Main concerns

On the European Commission's
eco-design and **energy**
labelling working documents
on light sources
(published: 13 November 2017)

24 January 2018

LightingEurope – List of comments to European Commission’s proposal on a Single Lighting Regulation
Date: 24 January 2018

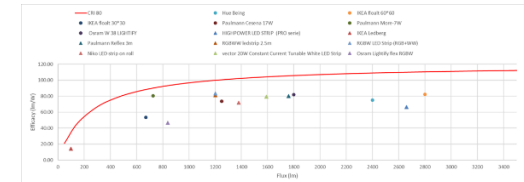
Although "ANNEX VI – BENCHMARKS" describes efficiency benchmarks for LED products, it misses to consider connected light sources. Also, it seems benchmarking has focused on retrofit LED lamps, and excluded tunable luminaires and LED strips with typical much higher fluxes. Below figure illustrates a set of connected white and color tunable LED luminaires and strips for different vendors available on the market, plotted versus the energy efficiency requirement. It shows that none of the products meets the energy efficiency requirement (for

connected light sources), which is plotted by the red line.

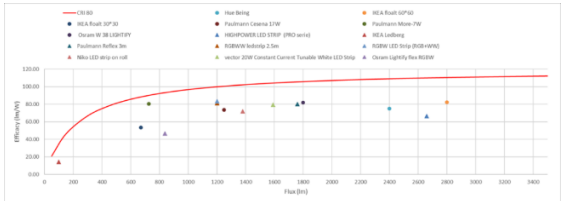
<p>(3) An accelerated operation life test as specified in relevant standards. Where no standard is available, the duration of this test shall be <i>1000h</i>. The model shall be operated continuously without switching at a temperature corresponding to 10°C above the maximum specified operating temperature if declared by the manufacturer. If there is no declared value or the value is below 40°C, then the test shall be performed at 50°C. Any thermal protecting devices that would switch off the model or reduce its performance shall be bypassed.</p>	<p><i>LightingEurope proposes to maintain the 500 hrs early survival test and to eliminate the accelerated lifetime test.</i></p> <p>[insert 500 h proposal from VHK's proposal]</p>	<ul style="list-style-type: none"> - Accelerated life test: Is different for LED modules, LED lamps and LED luminaires. For the last two this is a problem, they cannot be operated on a temp +10 degrees above the maximum specified temp by manufacturer. There is not a lot of evidence for performance in this area. - Testing in a climate chamber at elevated, well controlled temperatures is very expensive for the surveillance authorities. - 50C ,Testing with the thermal protection disabled is not reasonable. The failure does not occur in real application with a working NTC protection. - This test is to check for catastrophic failures. It is also mentioned that 'An accelerated test should not evoke fault modes or failure mechanisms which are not related to normal life effects. For example, a too high temperature increase would lead to chemical or physical effects from which no conclusions on real life can be made. <p>In general we propose to maintain the 500 hrs early survival test. With these proposals the good will suffer from the bad..</p>

At the end of this test, and after cooling down to room temperature and being stabilized, all 3 models (if sample size used is 3) or 9 of 10 models (if sample size used is 10) shall operate and have a luminous flux that is not less than 80% of the initial luminous flux for a period of at least 15 min.	At the end of the test, and after cooling down to room temperature and being stabilized all 3 models (if sample size used is 3) or 9 of 10 models (if sample size used is 10) shall operate and have a luminous flux that is not less than 80% of the initial luminous flux operate for a period of at least 15 min.	Exclude the lm maintenance criteria from here as well. There is no transfer function that can be determined between the lm maintenance at operating temperature and at higher temperature. The 1000 hrs is very short to evaluate lm maintenance (at 1000 hrs the lm maintenance may be even more than 100%).

ANNEX III - Label for light sources

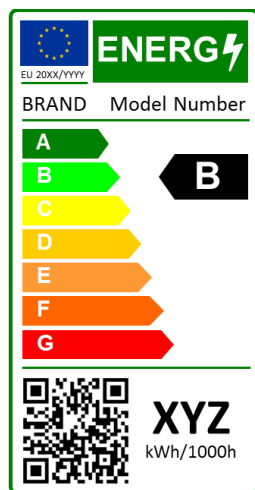
I. trademark or supplier's name;		
II. model identifier), meaning the code, usually alphanumeric, which distinguishes a light source model from other models with the same trade mark or supplier's name;		
III. the energy efficiency class determined in accordance with Annex IV; the head of the arrow containing the energy efficiency class of the light source shall be placed at the same height as the head of the arrow of the relevant energy efficiency class;		
IV. a quick response code (QR-code) redirecting to a website optimized for mobile devices where additional information on the light source can be found;	IV, a quick response code (QR-code) redirecting to to a website optimized for mobile devices the homepage of the public part of the PRODUCT DATABASE ESTABLISHED BY REGULATION (EU) 2017/1369 , where additional information on the light source can be found;	The link in the QR code is not clear; obligatory QR code in the label is limiting (blocking) the use by suppliers to have their own QR code - double QR codes will confuse to end-users. Therefore, link of the QR code should be towards EPREL (public part).

V. the energy consumption (XYZ), expressed in kWh of electricity consumption per 1000 hours of light source on-mode operation.	V. the energy consumption (XYZ), expressed in kWh of electricity consumption per 1000 hours of light source on-mode operation. Wh have to be rounded to the upper nearest integer.	Point V is too vague: it should be specified that the figure should be rounded with the same rule as in Regulation. 874/2012.

(3) The label shall meet all the following requirements in its standard size. If the label is printed in a larger format, its content must nevertheless remain proportionate to the specifications for the standard size below: (XXX)	Add: the dimensions of the label as in Regulation 874/2012	Dimension of the label is missing.

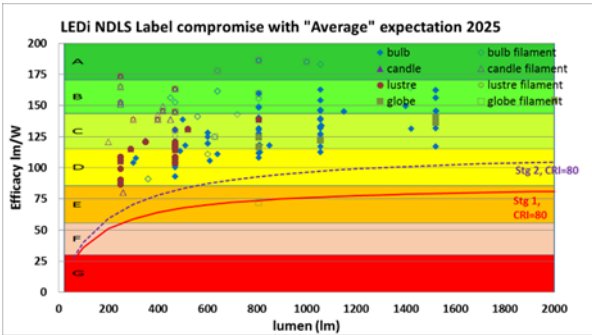
The limit for class G is wrong.

- The classes are too different from the current label.
- Example: LED filament lamps A++>> E
Trust in label is lowered, resulting in that consumers might accuse the suppliers of cheating with current products.

<p>- Is there sufficient market study done on the end-user perception/ behaviour (in case of rescaling labels) proofing the positive effects of such rescaling? If not, market end-user acceptance study should be performed. If yes, this study should be shared.</p> <div><p>LEDi NDLS Label compromise with "Average" expectation 2025</p></div>												
<p>Table 2 Factors F_{TM} to be used for determination of $\eta_{TM} = (\Phi_{use} / P_{on}) * F_{TM} (lm/W)$</p> <table><tr><th>Light source type</th><th>Factor F_{TM}</th></tr><tr><td>Non-directional mains light source (NDLS, MLS)</td><td>1.000</td></tr><tr><td>Non-directional non-mains light source (NDLS, NMLS)</td><td>0.926</td></tr><tr><td>Directional mains light source (DLS, MLS)</td><td>1.176</td></tr><tr><td>Directional non-mains light source (DLS, NMLS)</td><td>1.089</td></tr></table>	Light source type	Factor F_{TM}	Non-directional mains light source (NDLS, MLS)	1.000	Non-directional non-mains light source (NDLS, NMLS)	0.926	Directional mains light source (DLS, MLS)	1.176	Directional non-mains light source (DLS, NMLS)	1.089		<table><tr><td>Non-directional mains light source (NDLS, MLS)</td><td>1.000</td></tr></table> <p>In the column Factor F_{TM}, the decimal separator shall be a comma and not a point.</p>	Non-directional mains light source (NDLS, MLS)	1.000

Change:
G : $\eta_{TM} < 85$
